**Change in Packaging Box to Prevent Tampering with MELSEC-Q Series Products**

May 2022

Q03UDVCPU, Q04UDVCPU, Q06UDVCPU, Q13UDVCPU, Q26UDVCPU

FA-A-0375-A

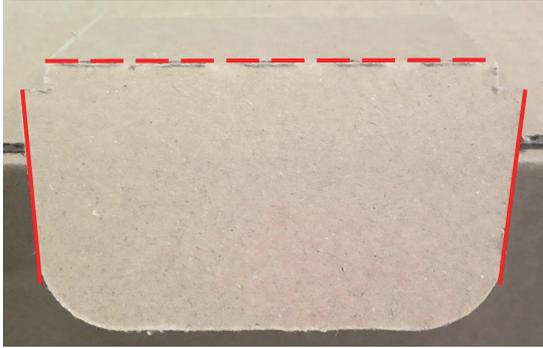
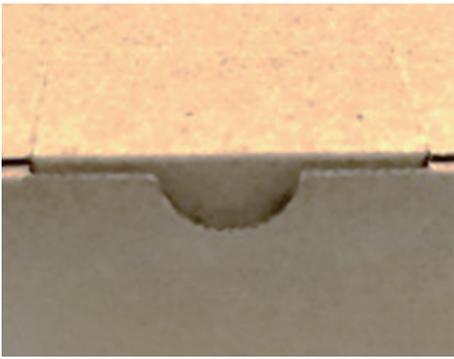
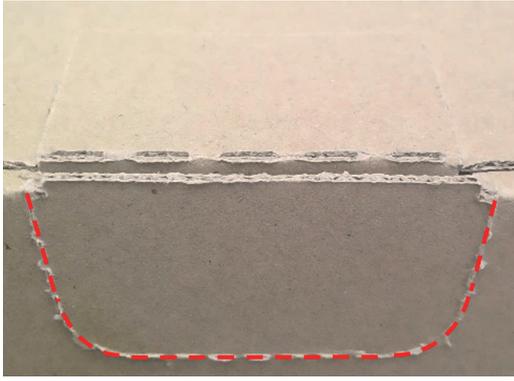
Item	Before change	After change
Insertion part		<p data-bbox="874 456 1449 506">Insertion part will be changed to the tapered shape, and perforations will be added.</p> 
Side		<p data-bbox="874 898 1129 947">Perforations will be added. A trace of opening will remain.</p> 
Bottom		<p data-bbox="874 1364 1193 1391">Two points to be pasted will be added.</p> 
External appearance (front)
